Proposal for Supplement 3 to the 05 series of amendments Regulation No. 22 (Protective helmets)

Submitted by the expert from Belgium

Type approval scheme (Flow chart)

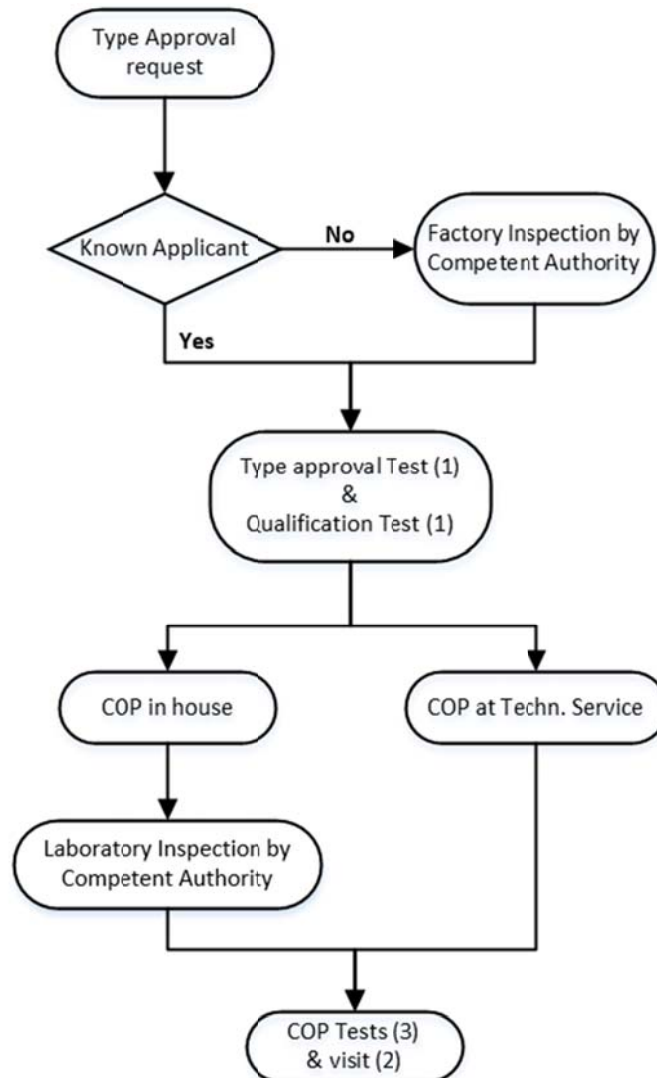
- (2) Visit of the manufacturer for inspection and random sampling by the authority or technical service:
 - a) if there is no ISO 9002* or an equivalent standard : ~~3~~ **1** times a year

- b) if there is an ISO 9002* or an equivalent standard : 1 time **every 1 to 2 years, depending on the results of the inspection.**
 - (3) Tests in accordance to paragraph 10.5 and/or 10.6 on samples taken out of the production:

- a) if there is no ISO 9002* : of the authority or technical service during the visit of footnote 2 a)
 - b) if there is an ISO 9002* : taken by the manufacturer, procedure checked during visit of footnote 2 b)

- * **or an equivalent standard, i.e. one that delivers the same or better levels of quality."**

The flowchart has been simplified but there is no change of content.

Currently all the contracting parties do not respect the frequency of visit for inspection and random sampling indicated at annex 12, it is indeed disproportionate. The proposal aims to have a frequency more appropriate while ensuring an effective control of the conformity of production and which could be respected by all contracting parties.
